UNITED STATES PATENT AND TRADEMARK OFFICE

APPLICATION NO.	FILING DATE	FIRST NAMED INVENTOR	ATTORNEY DOCKET NO.	CONFIRMATION NO.
10/810,887	03/29/2004	Hak-Sun Chang	YOM-0206	1078

Office Action Summary

DETAILED ACTION

FIG. 4B

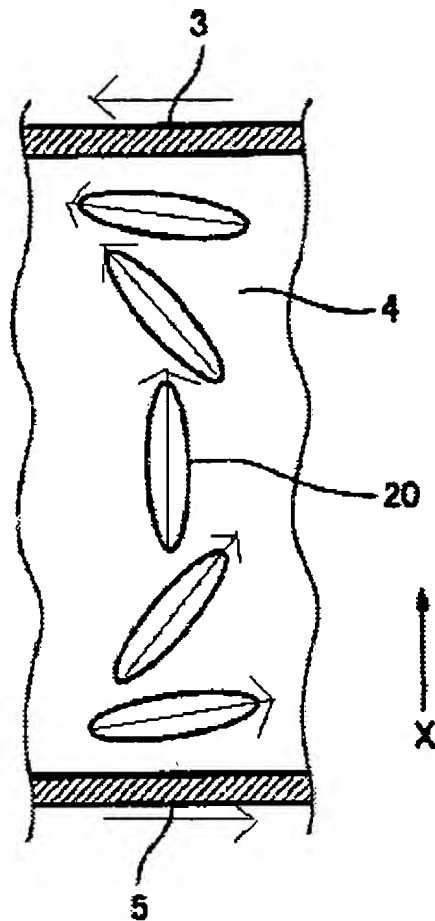
Applicant has also stated the reference does not teach liquid crystal that is arranged in antiparallel on both substrates. The reference discloses rubbing treatment such that the alignment layers are rubbed parallel to the signal lines (see column 10 lines 60-68) and align in the same direction on a particular substrate. Therefore in light of fig. 4B (see below) the liquid crystal must be aligned in antiparallel since they are parallel to the source lines at rubbed surfaces.

Regarding claims 1, 6 and, Yamakita 6661491 teaches a liquid crystal display with a common electrode (fig. 3 element 2) thereon; a liquid crystal layer (fig. 4a and 4b

element 4) injected between the upper and lower substrates (fig. 4b elements 3 and 5) and spacers (not shown in figs for this embodiment see column 10 lines 20-28; however shown in fig. 24 element 61), the spacers in the pixel region determining a gap (see fig. 24) between the upper and lower substrates and wherein the liquid crystal molecules are aligned antiparallel to each other (fig. 4B). The reference fails to teach the spacers being black or any color however, Sato teaches black spacers, that provided sharp and clear images (see column 4 lines 22-25). Therefore, at the time of the invention, it would have been obvious to one of ordinary skill in the art to apply black spacers to provide sharp and clear pictures.

Regarding claims 12 and 18, Yamakita 6661491 teaches a liquid crystal display with a common electrode (fig. 3 element 2) thereon; a liquid crystal layer (fig. 4a and 4b element 4) injected between the upper and lower substrates (fig. 4b elements 3 and 5) and spacers (not shown in figs for this embodiment see column 10 lines 20-28; however shown in fig. 24 element 61) positioned between the upper and lower substrate and within a pixel region, the spacers in the pixel region determining a gap (see fig. 24) between the upper and lower substrates and wherein the liquid crystal molecules are aligned antiparallel to each other (fig. 4B). The reference fails to teach the spacers
